Date: September 11, 2024

Project: Courtice Mixed Use Seniors Development at 1697 Highway # 2

Addendum No. 1

Mechanical Addendum No. M1

A902

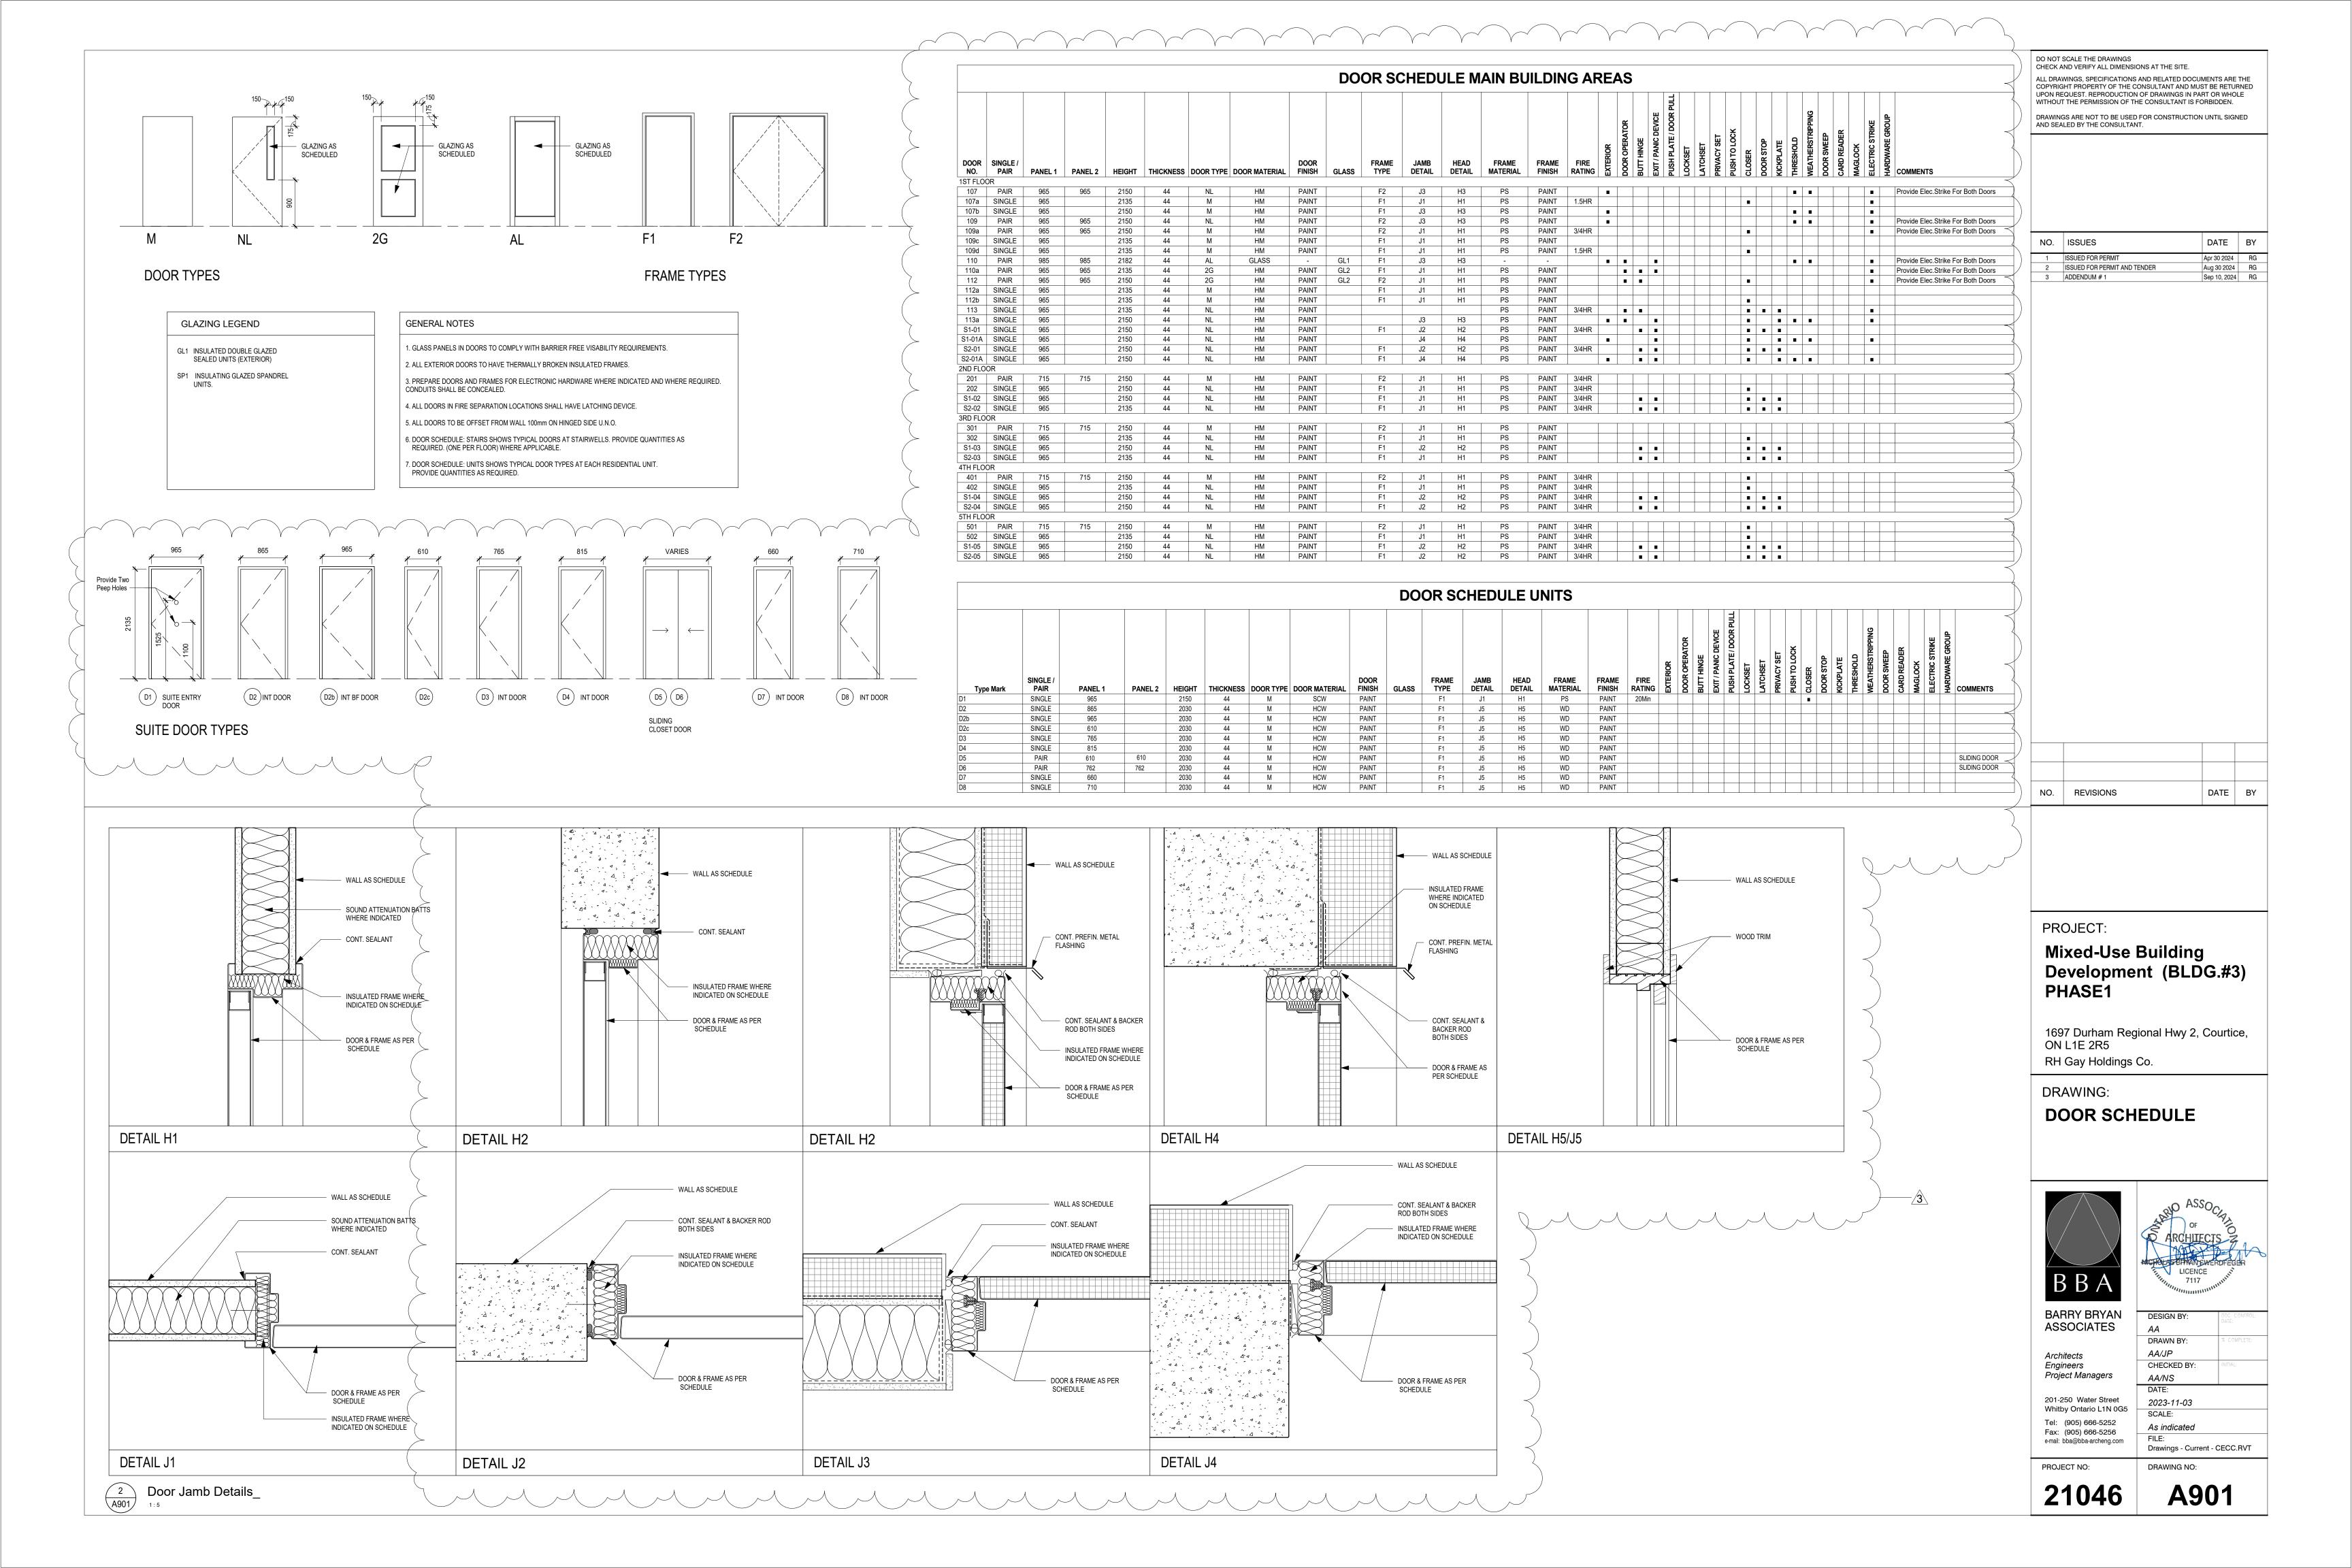
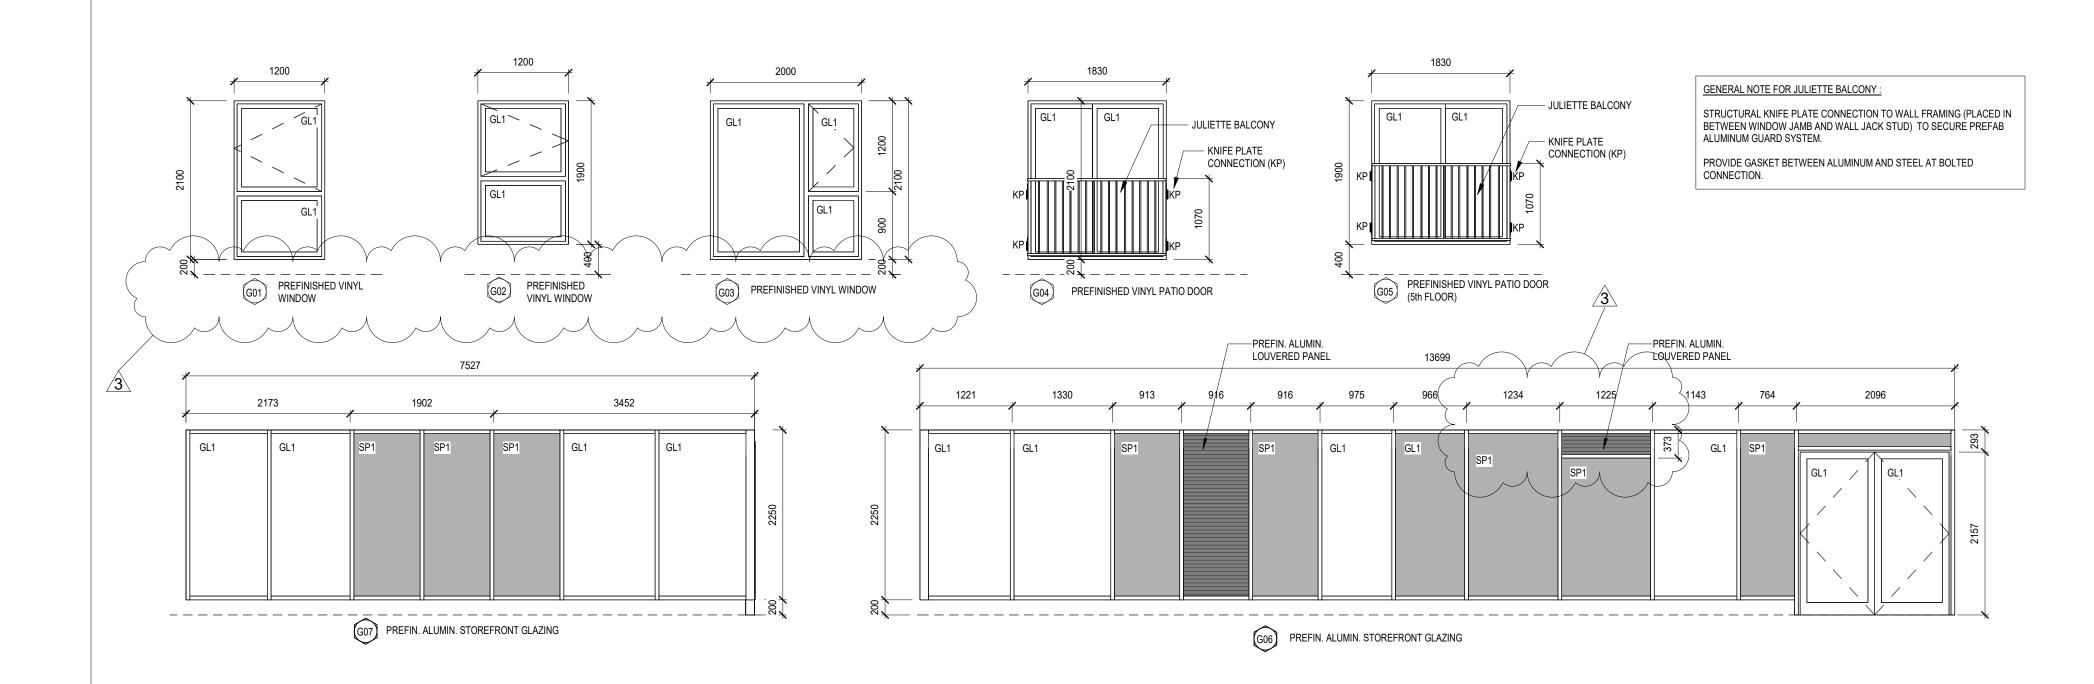
.1 Louver revised, Drawing titles updated. Refer to BBA Drawing No. A902 dated September 10, 2024.

GROUND FLOOR

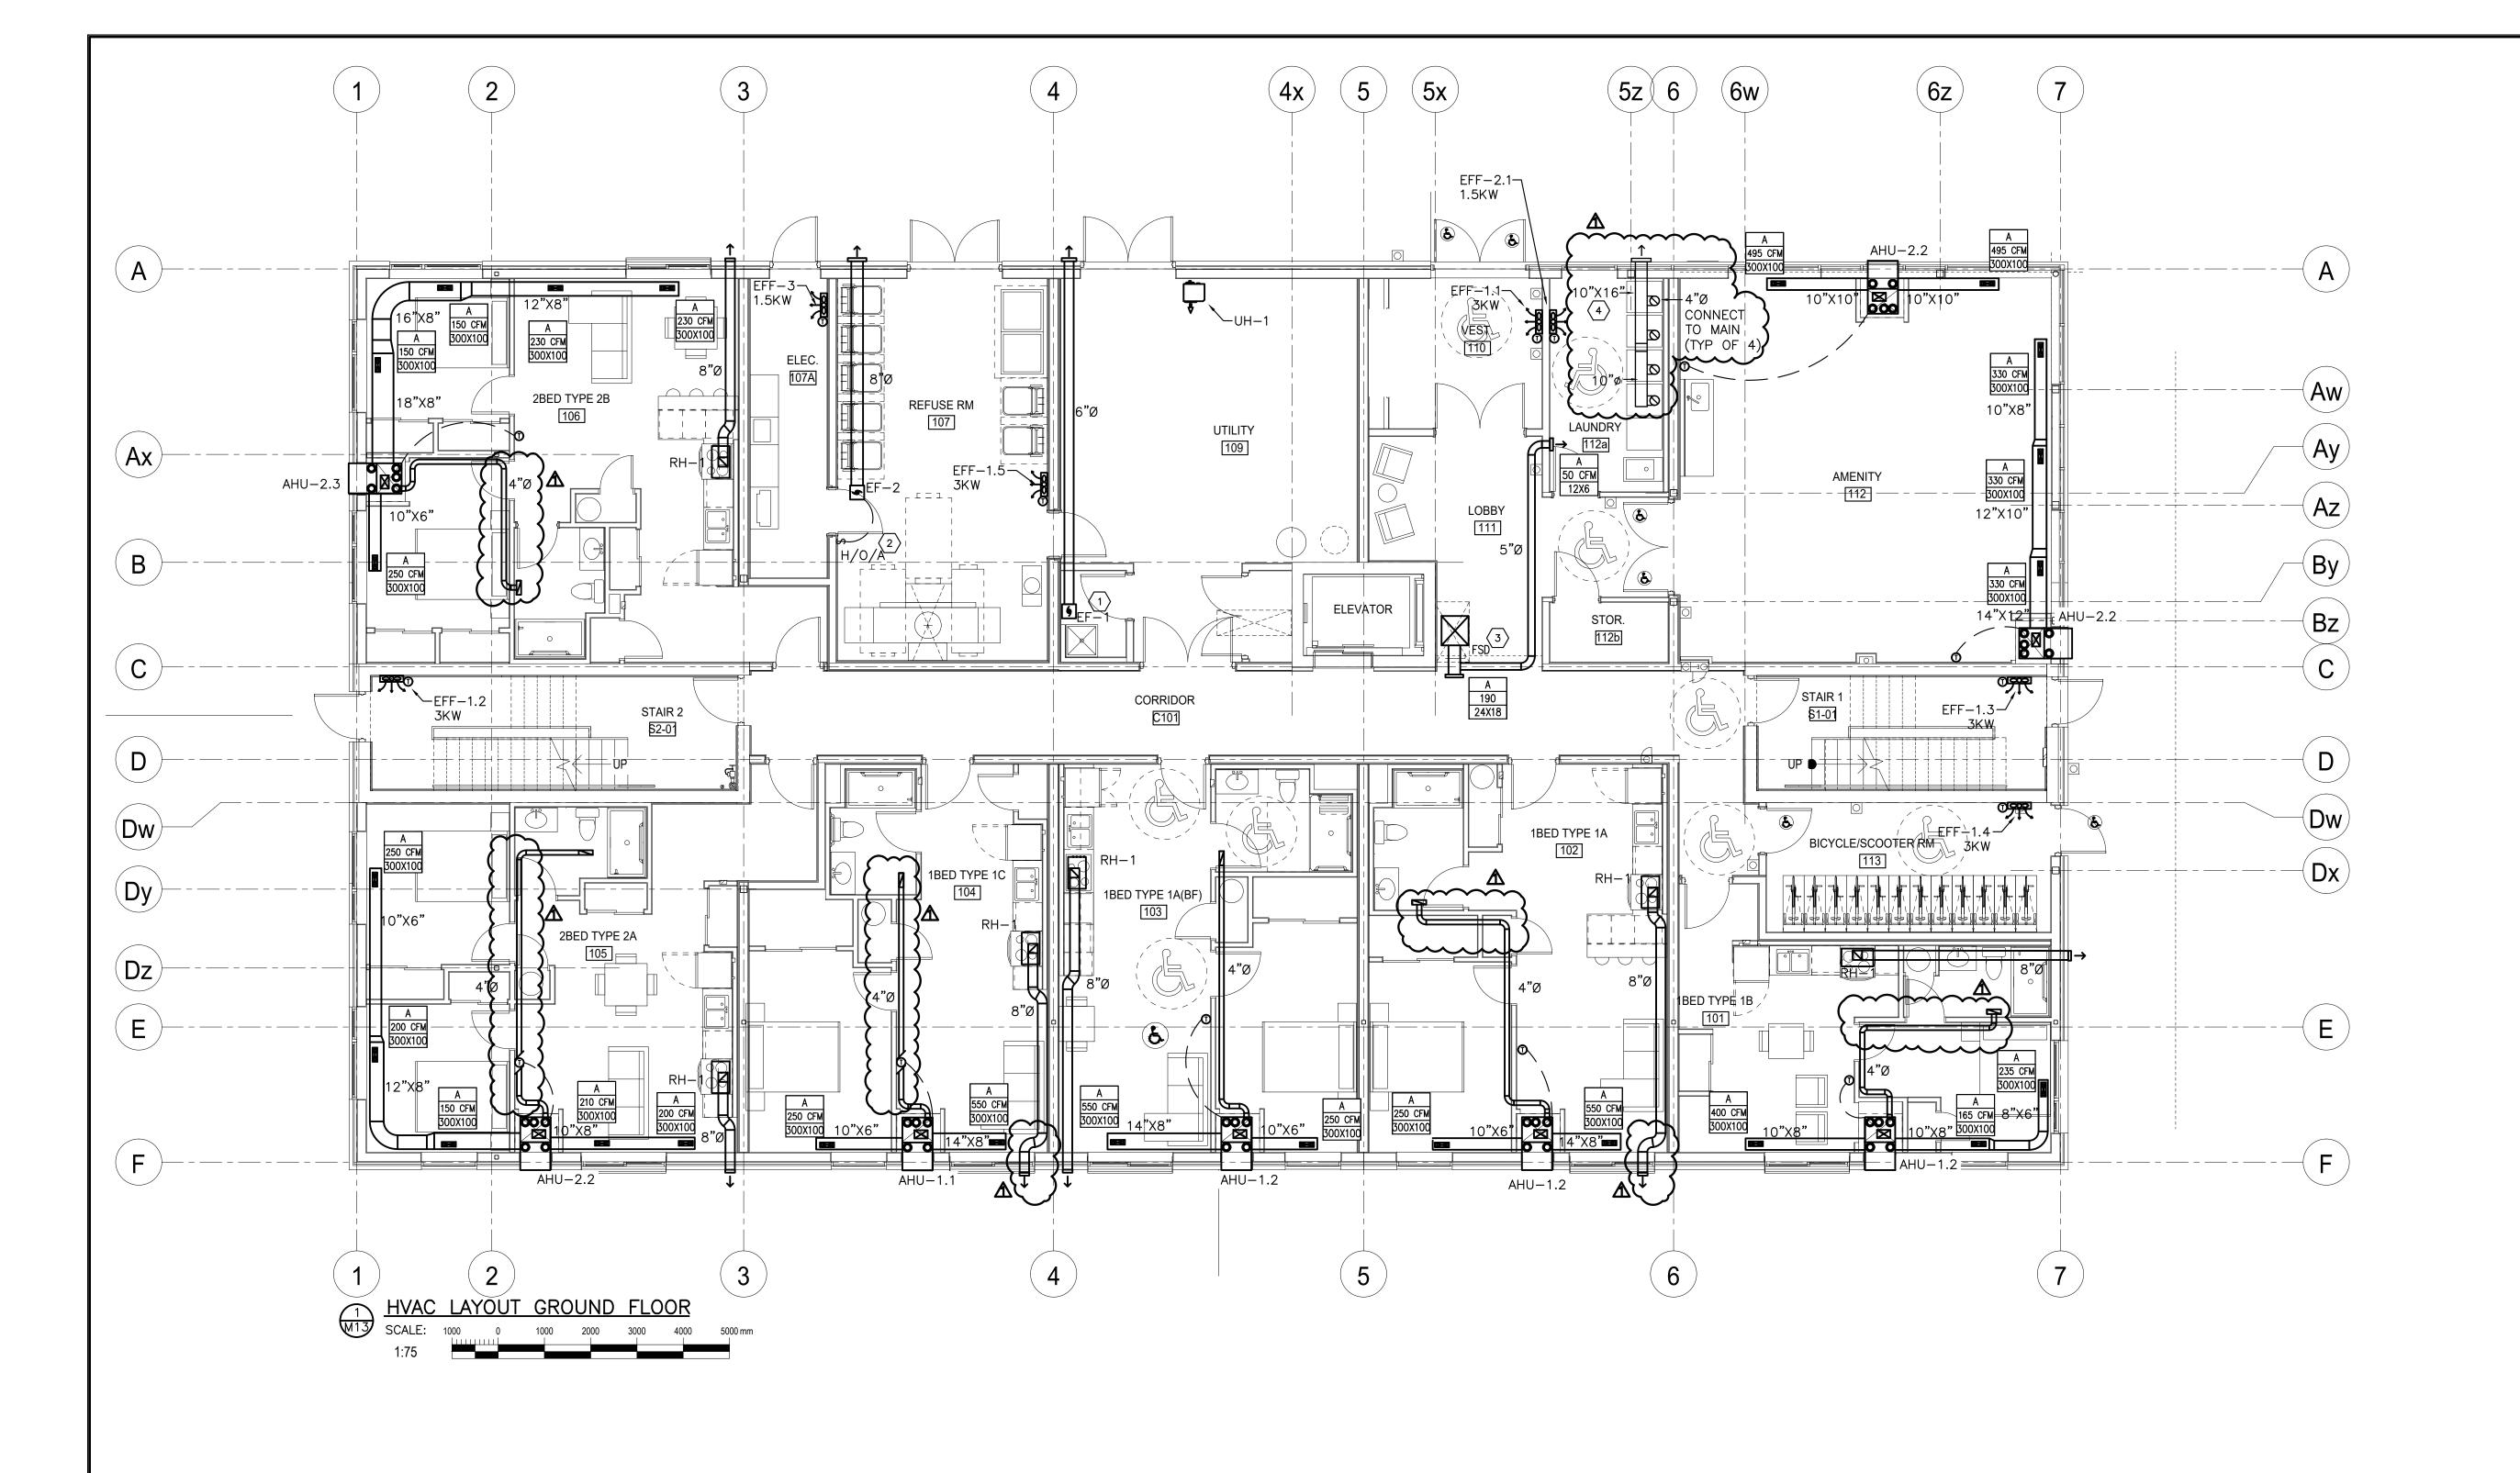
.1 Duct Layout Revision. Refer to Kirkland Engineering Ltd.'s Drawing No. M13 dated September 9, 2024.

1. Dryer vent sizes adjusted to coordinate with lintel.

- 1. Some suite range hood exhaust routing adjusted to coordinate with lintel. Changes bubbled on drawing.
- 2. Some suite ERV return ducting adjusted to fit in bulkhead (by architectural). Changes bubbled on drawing.
